AMENDMENT OF SOLICITATION/MODIFICATION OF CONTRACT			1. CONTRACT ID CODE	PAGE OF PAGES
2. AMENDMENT/MODIFICATION NO. 0006		3. EFFECTIVE DATE 05-Jun-2008	4. REQUISITION/PURCHASE REQ. NO.

**Request for Clarifications Regarding  
Solicitation W917PM-08-R-0043  
2/209<sup>th</sup> HQ Facilities, ANA Kunduz Phase II, Afghanistan  
RFI # 4 5 June 2008**

2/209TH HQ FACILITIES, ANA KUNDUZ PHASE II

2.7 FIRE STATION  
 PLAN  
 SUPPORT FACILITIES  
 AT ANA GARRISONS  
 AFGHANISTAN  
 MAY 2006

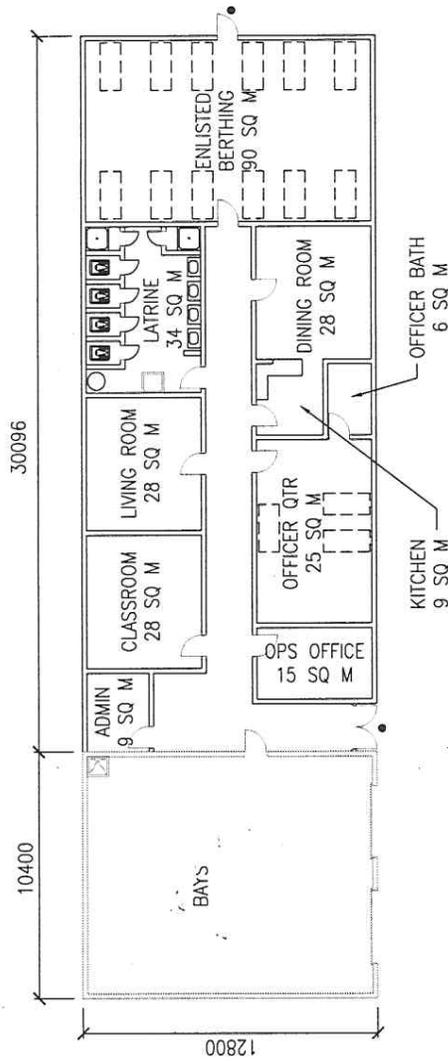
14. DESCRIPTION OF AMENDMENT/MODIFICATION (Organized by UCF section headings, including solicitation/contract subject matter where feasible.)				
1. The purpose of this Amendment is to make the following revisions: 2.7 Fire Station Plan - will change in its entirety 2. The amendment will also answer questions submitted under RF# 4 dated 5 June 2008. 3. All other terms and conditions shall remain unchanged.				
Except as provided herein, all terms and conditions of the document referenced in Item 9A or 10A, as heretofore changed, remains unchanged and in full force and effect.				
15A. NAME AND TITLE OF SIGNER (Type or print)			16A. NAME AND TITLE OF CONTRACTING OFFICER (Type or print)	
			TEL:	EMAIL:
15B. CONTRACTOR/OFFEROR	15C. DATE SIGNED	16B. UNITED STATES OF AMERICA		16C. DATE SIGNED
_____ (Signature of person authorized to sign)		BY _____ (Signature of Contracting Officer)

- a. Line item 000507 Fire Station Facility - Bldg 1021 on the Master Plan. Legend depicts 131SM, Appendix drawing and scope narrative shows 520SM. Please clarify the size of the Fire Station.

**A3.a** Section 01010 Scope of Work is correct. The Fire Station facility should be 520SM. The Appendix X FIRE STATION Plan Drawing (also shown as Appendix V on the FIRE STATION Floor Plan) is deleted by this amendment and replaced by the attached Appendix X FIRE STATION Plan Drawing.
